ORIGINATION FORM

Proposed Revisions to a Standard Plans Index
(Please provide all information — Incomplete forms will be returned)

Index Number: 102-660
Sheet Number (s): 2 of 2
Index Title: Sidewalk Closure

SIDEWALK CLOSURE

CHANGED TO: PEDESTRIAN DIVERSION (Work Zone Speed 35 mph or Less)

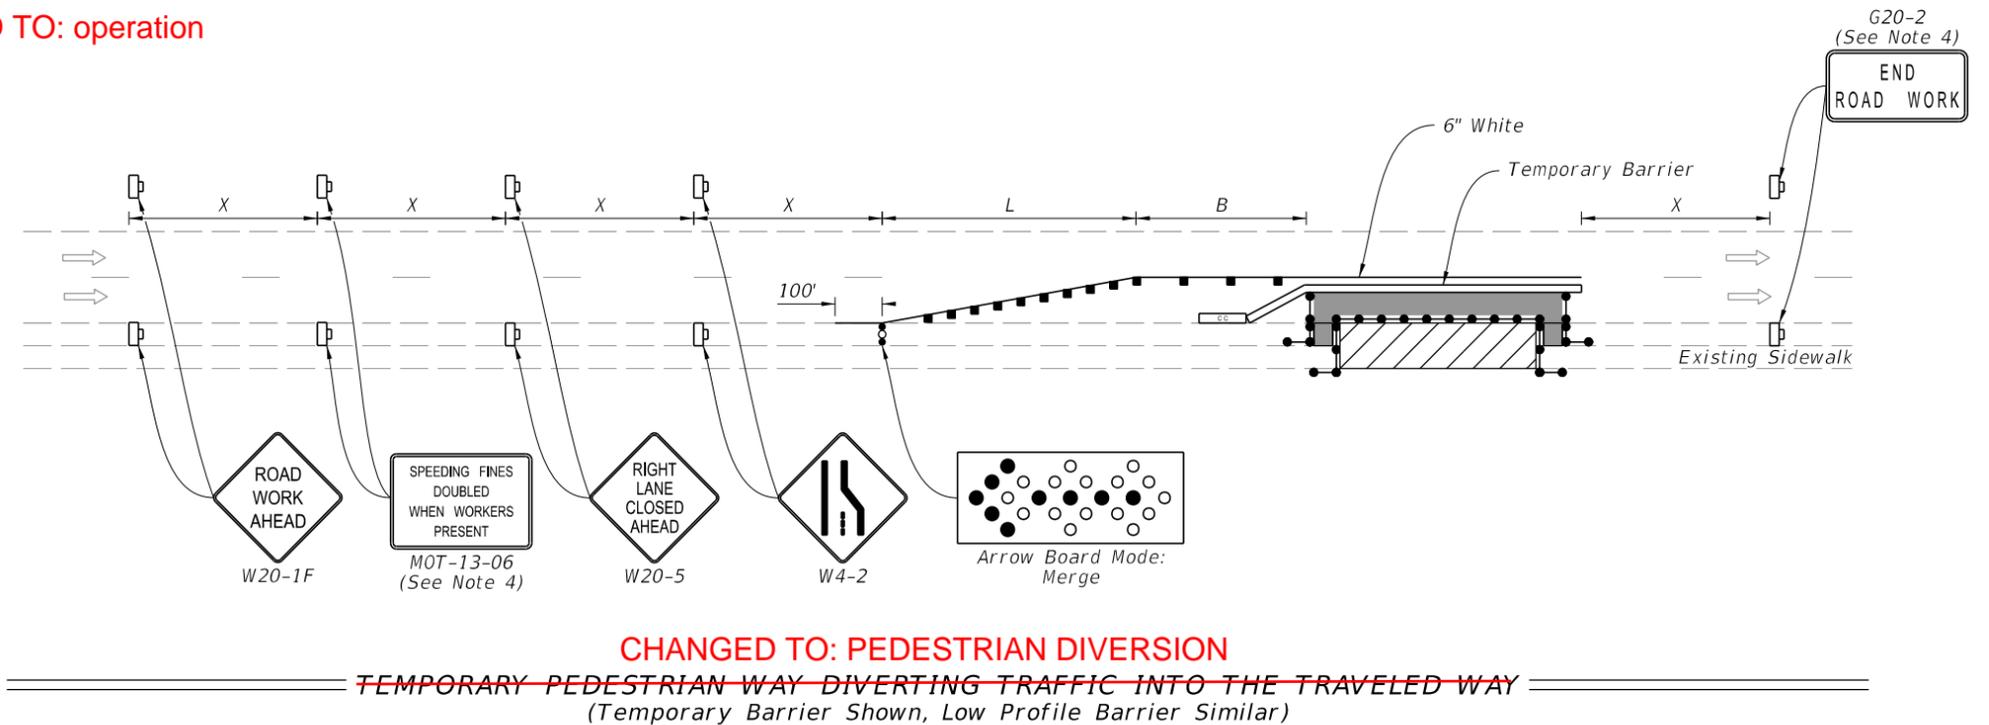
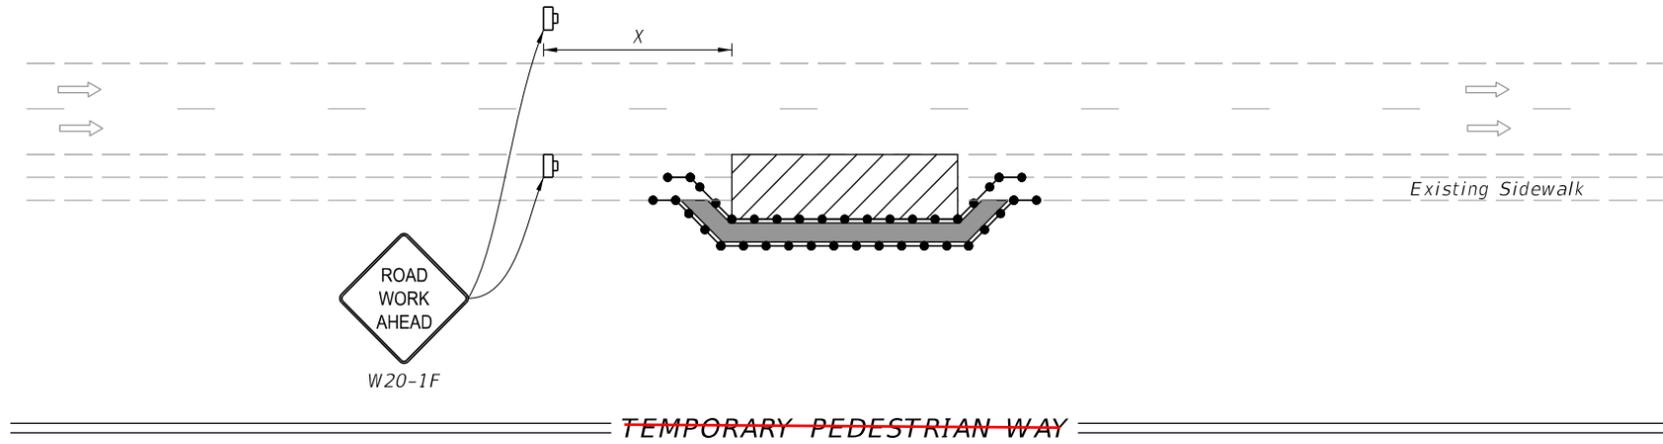
ADDED NEW DETAIL:

5. **CHANGED TO: operation**

ADDED NOTE 5:
Pedestrian Diversion may only be used when called for in the Plans or as approved by an Engineer.

PEDESTRIAN DIVERSION
(Work Zone Speed 35 mph or Less)

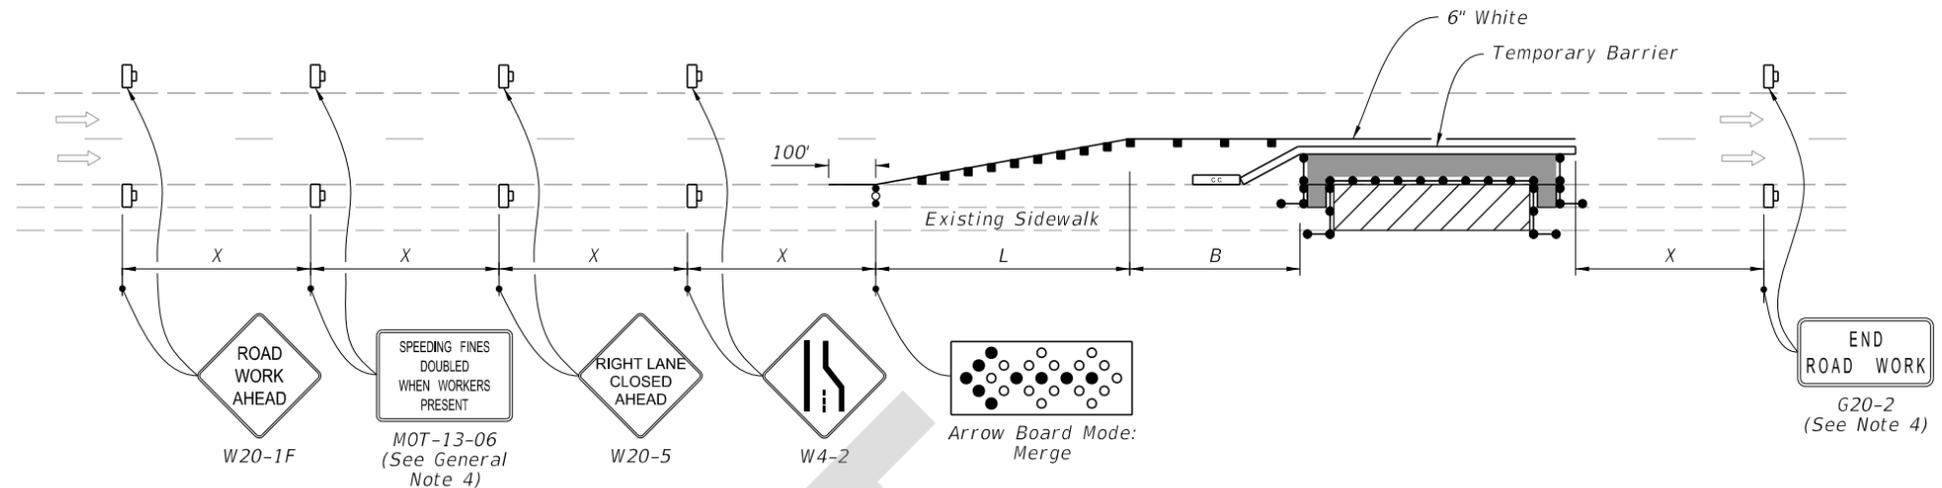
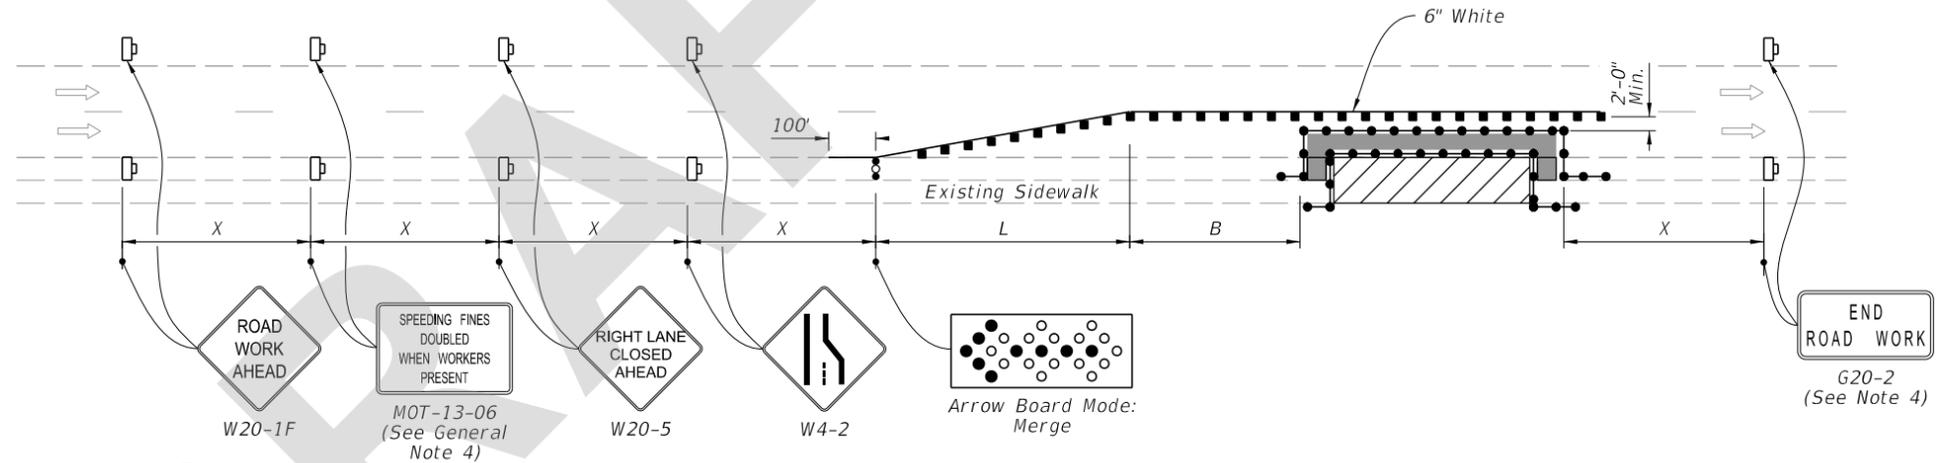
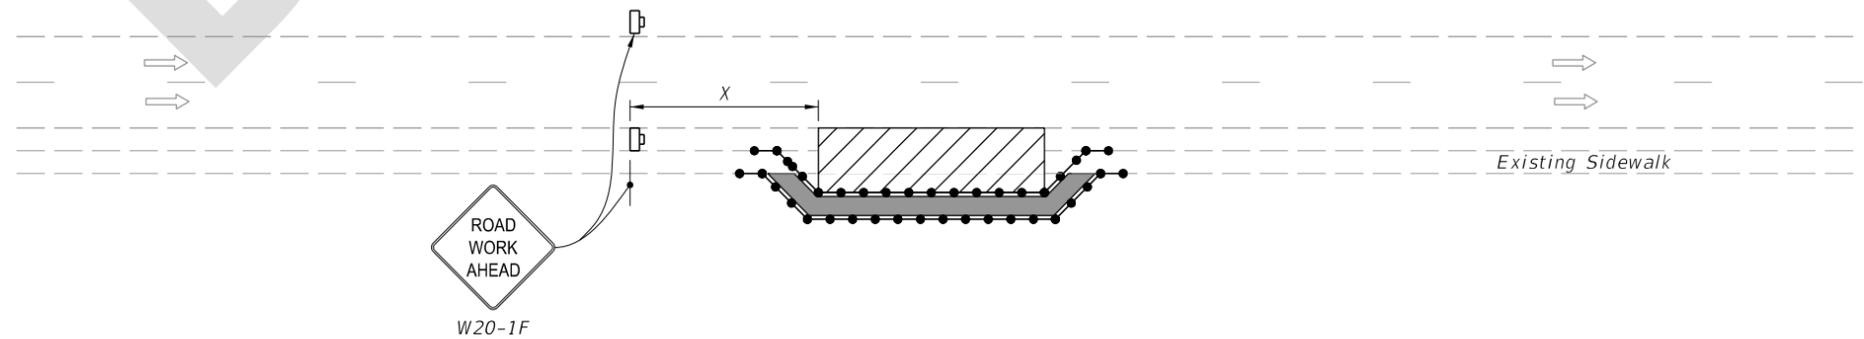
Sheet 2: Changed Note 4 - "work zone" to "work operations"; Added Note 5 - "Pedestrian Diversion may only be used when called for in the Plans or as approved by an Engineer."; Changed title "TEMPORARY PEDESTRIAN WAY" to "PEDESTRIAN SPECIAL DETOUR"; Changed title "TEMPORARY PEDESTRIAN WAY DIVERTING TRAFFIC INTO THE TRAVELED WAY" to "PEDESTRIAN DIRVERSION"; Added new detail "PEDESTRIAN DIRVERSION (Work Zone Speed 35 mph or Less).

5. Pedestrian Diversion may only be used when called for in the Plans or as approved by an Engineer.

PEDESTRIAN DIVERSION
(Temporary Barrier Shown, Low Profile Barrier Similar)

PEDESTRIAN SPECIAL DETOUR
